Use this instruction only when changing from A to C type iM.60 board!

The most important differences between A and C type iM.60 board are shown in the following pictures.

Connectors:

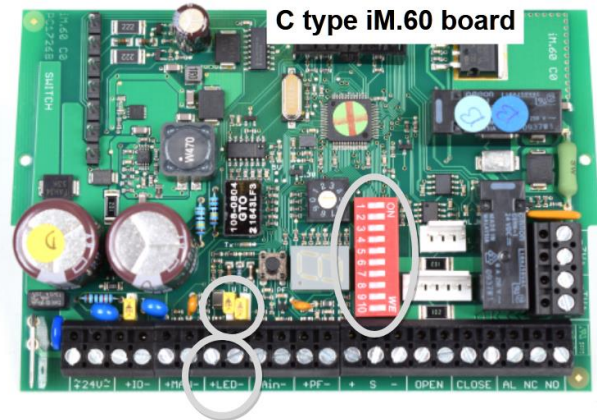
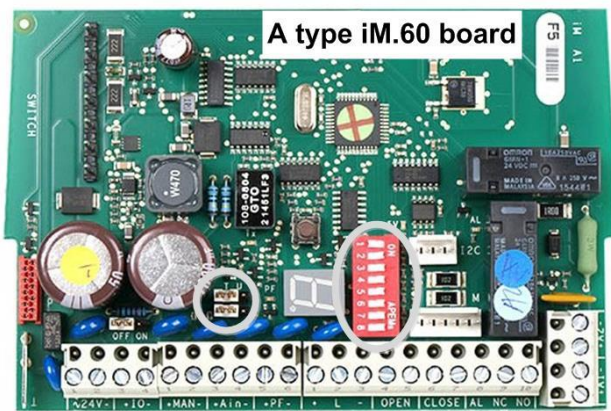
The C type board has an additional alarm led output. It's necessary to reconnect the wires.
